Building Department  
City of Rochester Hills

Proposed New  
Sign Location

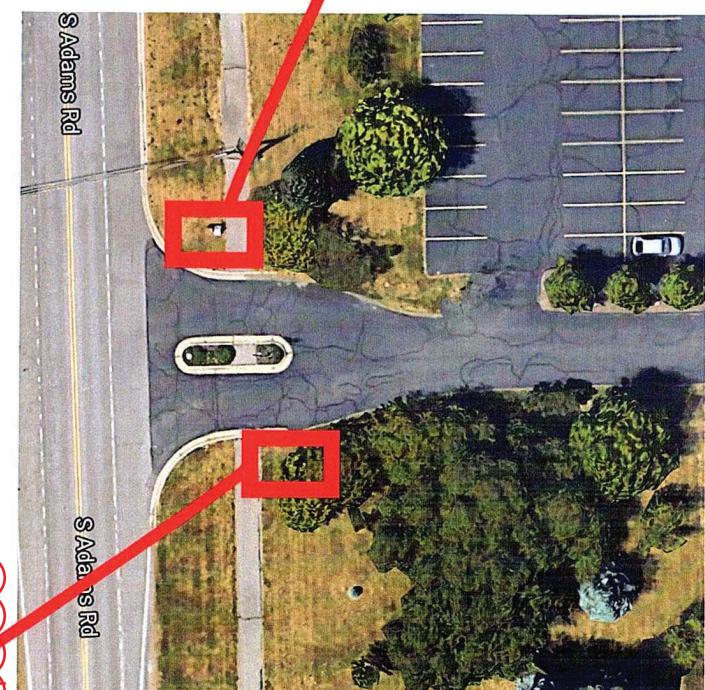
Require readable  
measurements.

Sign placement requires HDC  
approval.  
Contact Planning & Economic  
Development (248)656-4660

Also, see  
page 2

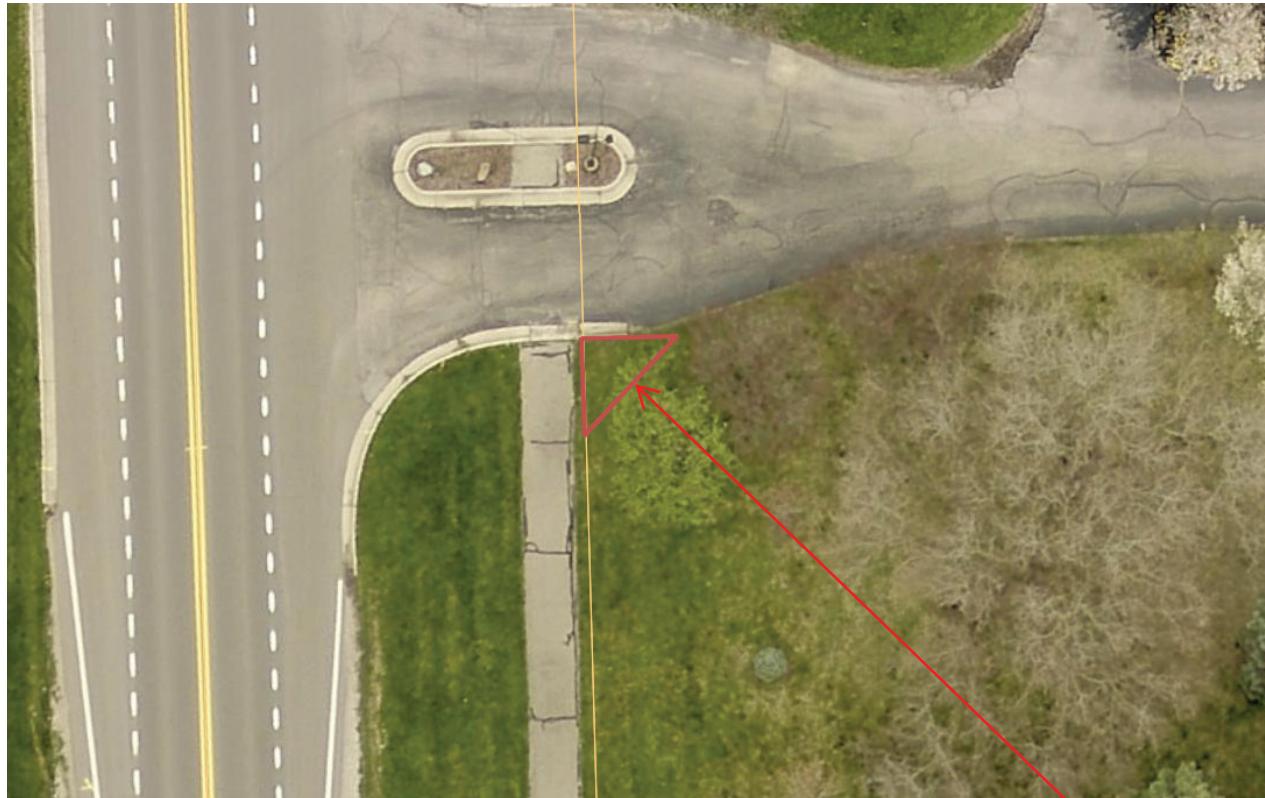
Sign must be located outside of corner clearance.  
Sec. 134-4(3)(a) no sign shall be placed within the  
triangular area at the corner of the intersection of a  
street right-of-way line and the edge of a private  
driveway for a distance along each line of 15 feet  
from their point of intersection
